MEMORANDUM
OFFICE OF THE STATE ENGINEER
Hydrology Bureau

SUBJECT: Additional Comments on Permit Revision 20-1 to Update Closure/Close Out Plan and Financial Assurance, Permit No. SF0002RE, Cunningham Hill Mine

Figure 1: Open Pit Lake and modeled water level elevations along with events that may affect the open water level (modified Figure 3 from JSAI, 2022).

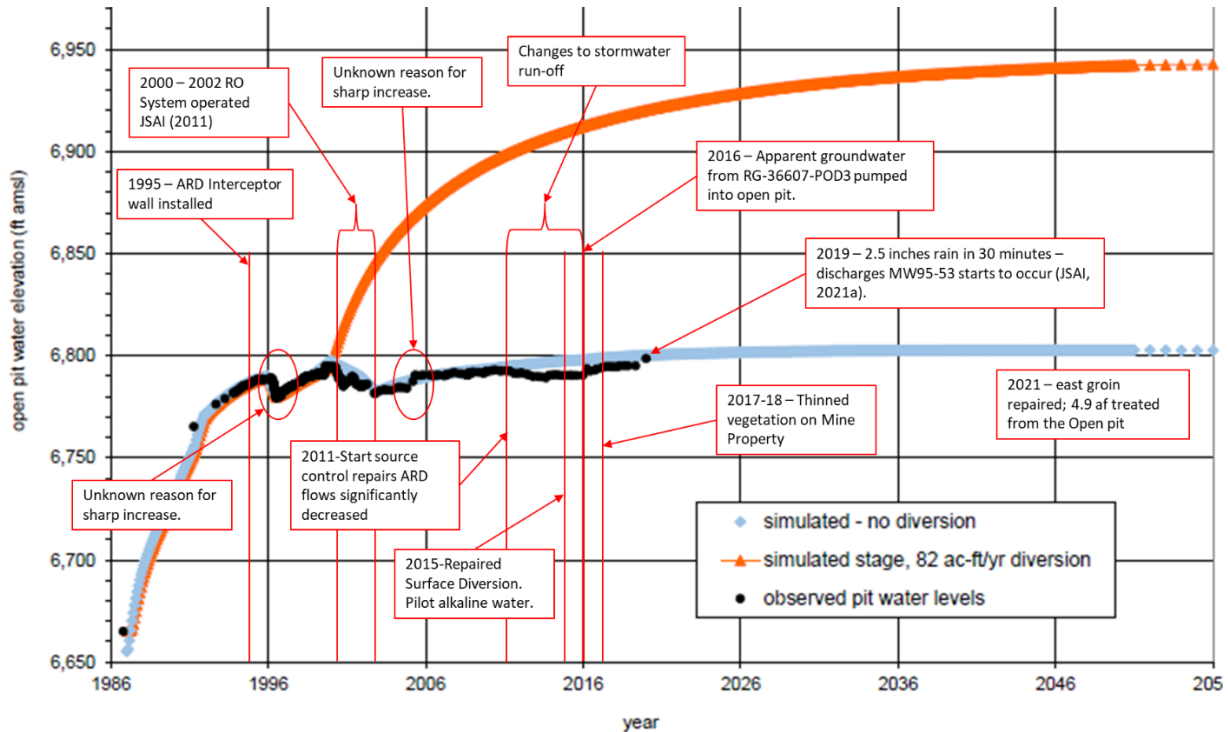
Figure 1 (modified Figure 3 from JSAI, 2022) documents the actual open pit lake water levels and the model results. There are many variations in the open pit water levels. These variations and the changes that may have created are listed below:

- 1) A sharp increase in the pit water level occurs in 2005. No documentation has been supplied for this increase in open pit water level has been supplied.
- 2) There is a decrease in water levels between 2011 and approximately 2013 that does not follow the "No diversion" simulation.
- 3) Between approximately 2013 and 2016 the water levels are relatively flat below the no diversion line.
- 4) In 2016 there was a sharp increase of approximately 5-feet in the open pit water level. This gain in open pit lake water level is not explained by the weir data and may be from

supplemental water being input into the open pit. This input of water would make the water levels appear to follow the no diversion line.

- 5) In 2019, the open pit lake water levels increase to nearly 6,800 ft msl. This nearly 5-foot increase in water level is partly due to a large rain event.
 - a. Surface water diverted into the pit was 20.91 ac-ft.
 - b. RG-36607-POD3 and the residue pile recovery system also pumped 13.61 ac-ft.
 - c. If no evaporative losses were suffered and no other water flowed in to or out of the open pit, then the estimated increase in the open pit water levels would be approximately 22 feet.

- 1) A summary table of all the inflows and outflows from the time mining ceased (1987) to the current time period. This table should include but is not limited to any water that was removed from the open pit lake for remediation, the amount of post treatment water returned to the pit, surface water diverted into the open pit lake, and groundwater that is pumped into the open pit lake.
- 2) A copy of all the current MODFLOW model files for the Cunningham Hill Mine.
